May 16, 2025

Re: Noise Impact Study Addendum 1
Duivenvoorden Haulage Shelburne Pit Expansion
4th Line
Melancthon, Ontario
VCL File: 1250085

Figure 1
Existing Berm and
Proposed Mitigation
Measures for Phase 1

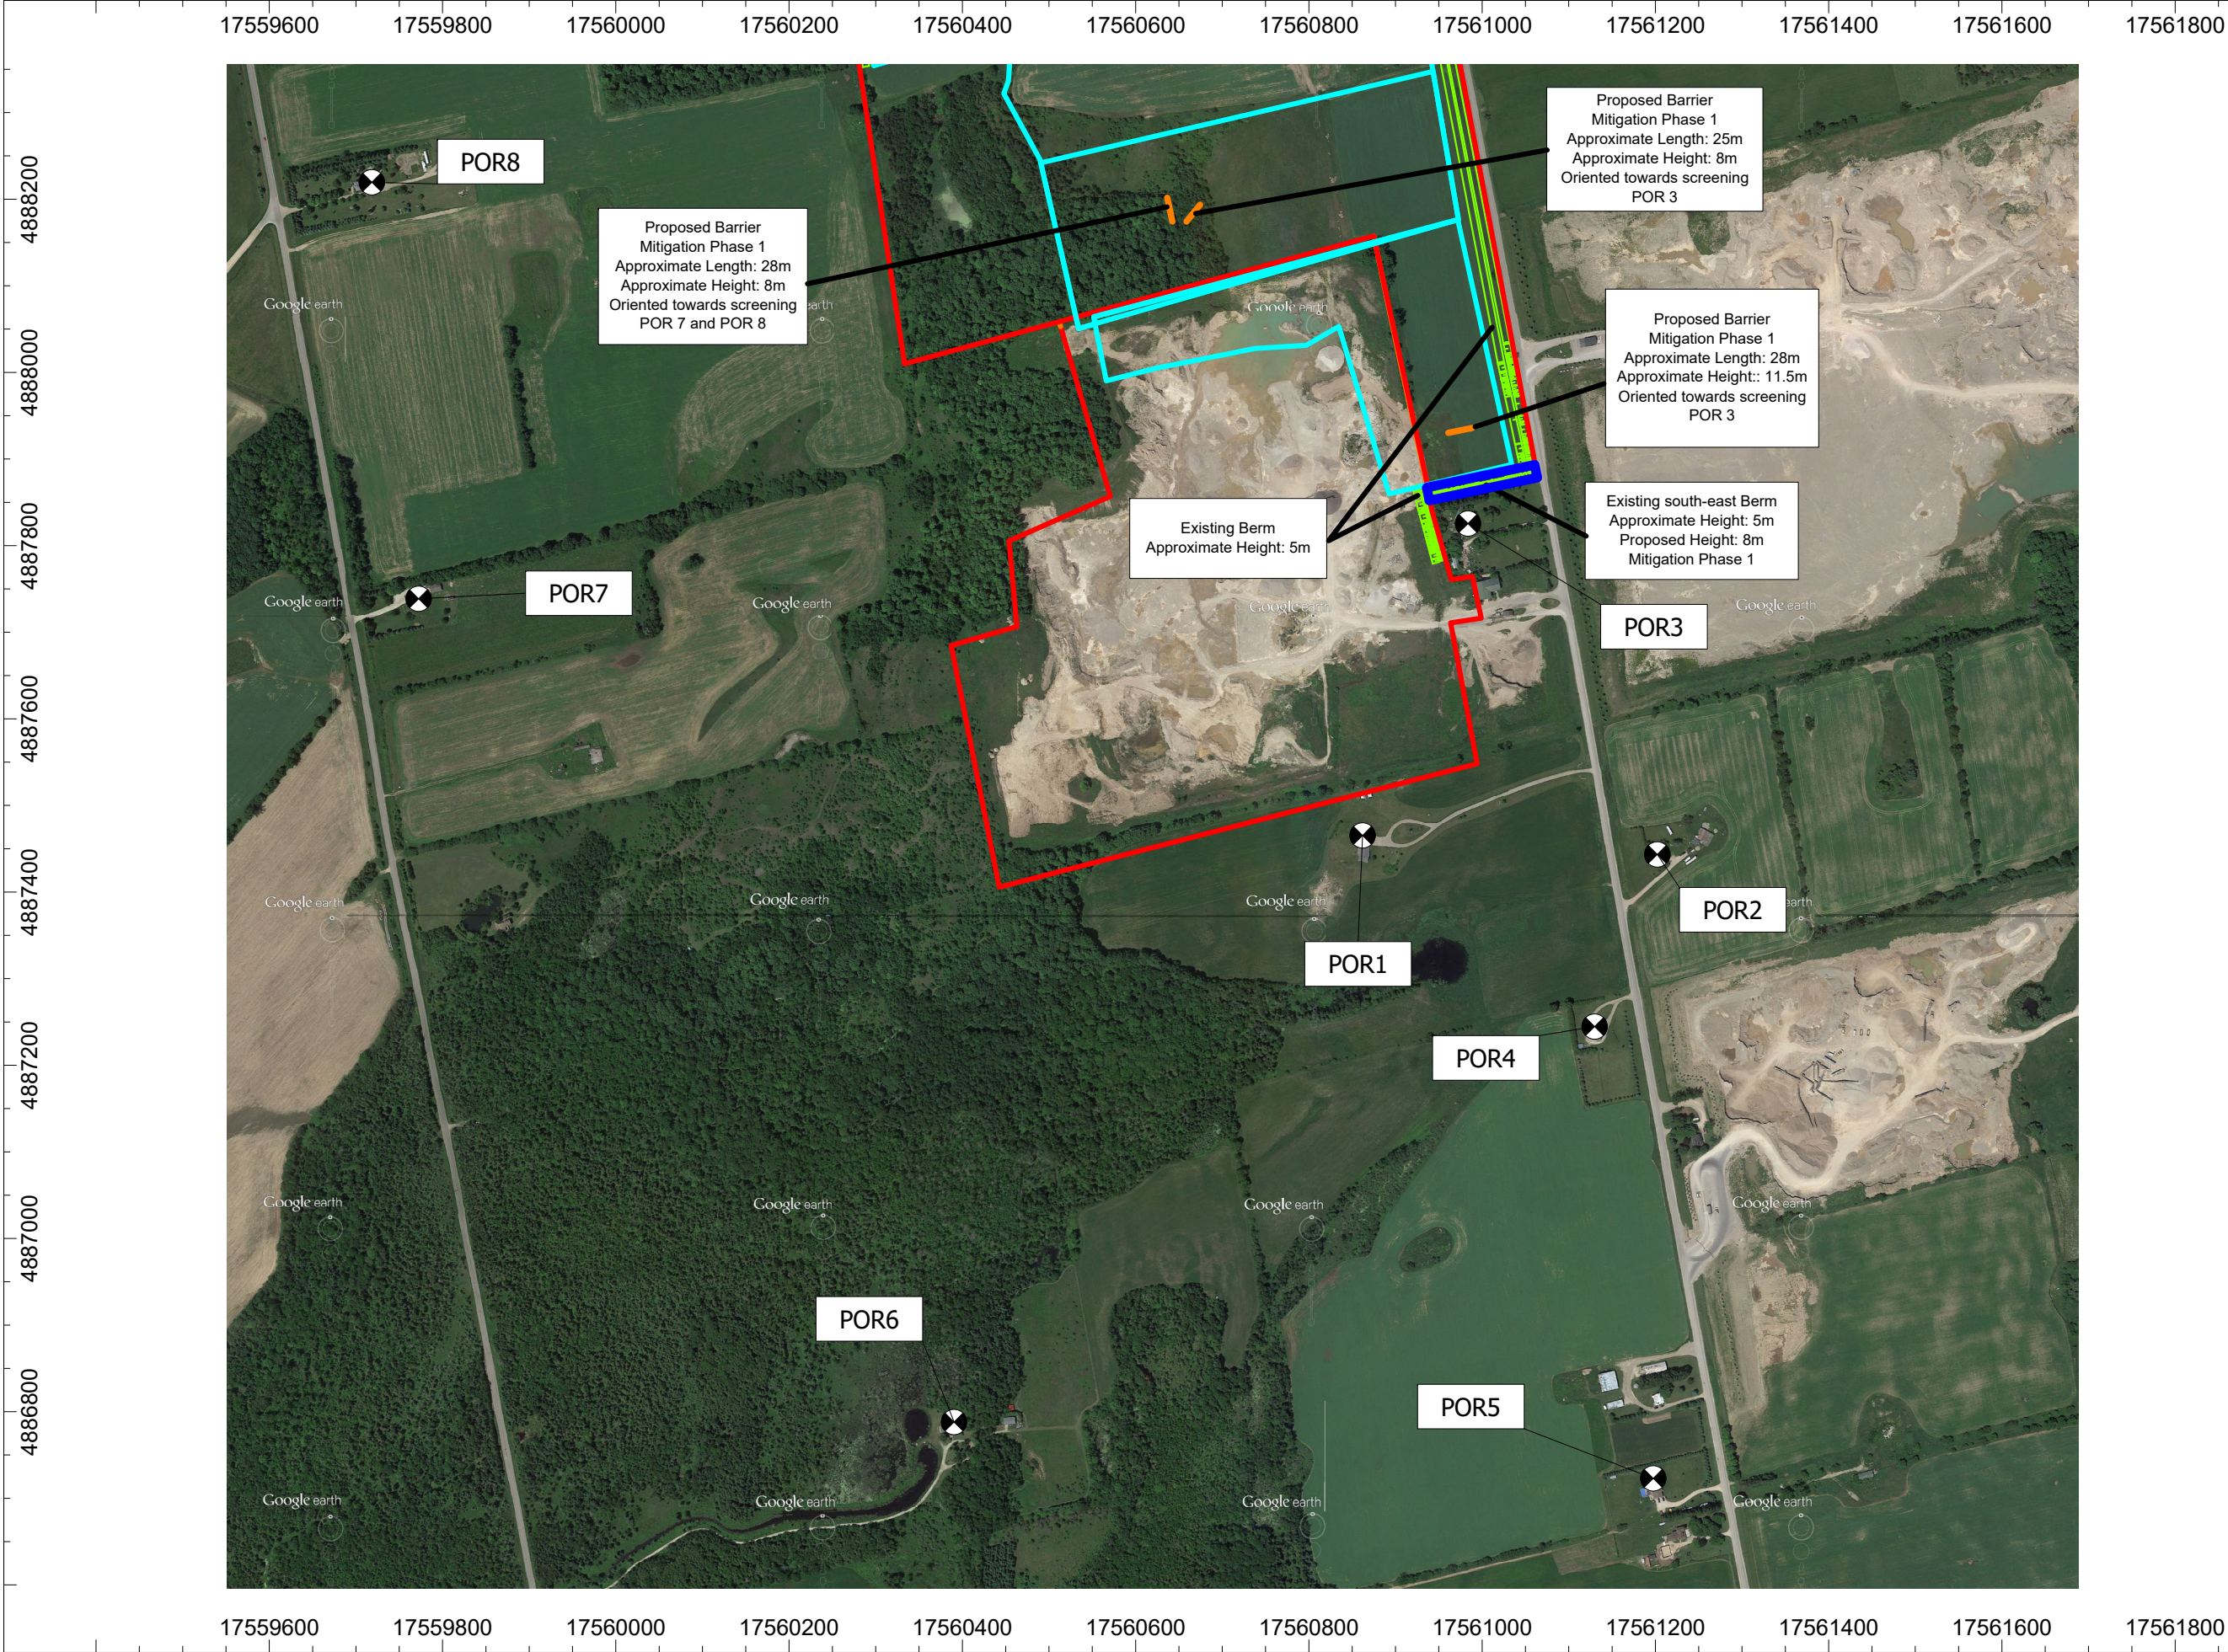
Raising the pit floor elevation by 3 m effectively reduces the inherent acoustical screening provided to the operating equipment since the height or the pit faces decreases by the same 3 m.

As shown in the above tables, sound levels at some of the receptors exceed the MECP noise guideline limits. To meet the guideline limits, these adjustments to the recommended noise mitigation measures are needed:

- Phase 1 - The east-west berm just north of POR 3 needs to be increased from 5 m to 8 m in height.
- Phase 2 – No change to mitigation requirements.
- Phase 3 – 5 m high berm along a portion of the western and northern extraction limits.
